East Midtown Greenway and Andrew Haswell Green Park 2B 53rd – 62nd St.
Response to 4/08/21 CB8 Parks & Waterfront Committee and 197-A Committee

Prepared by NYCEDC and NYC Parks
5/20/21

Photos enclosed for reference:

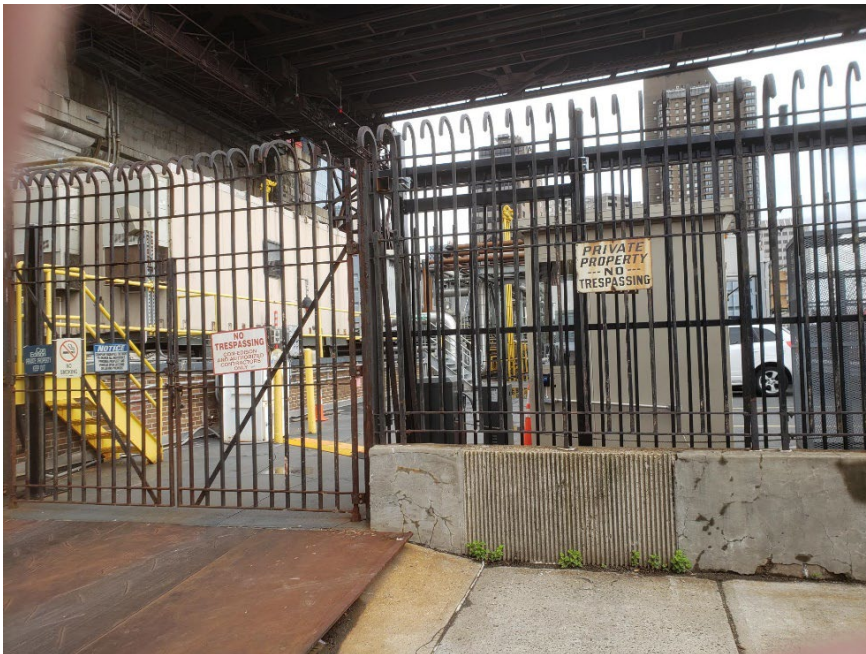
- 4. Connection between the 60th St. ramp at AHG2A and the Queensboro Bridge abutment and the end of E. 59th St.:** NYC Parks has looked into the possibility of a connection and deemed it infeasible.
 - There is about an 8’ to 9’ difference in elevation between the ramp and the terrace area, which would require a long length of ramp for a connection.
 - The terrace area is gated private/ConEd property and occupied by ConEd storage containers.
 - Due to the reasons above, a connection would therefore need to ramp over the SB FDR to 59th Street proper, 1 block. The only way to support a ramp would be via cantilever off the wall above the FDR, which has an unknown structural capacity, or to somehow hang it from the bridge above.
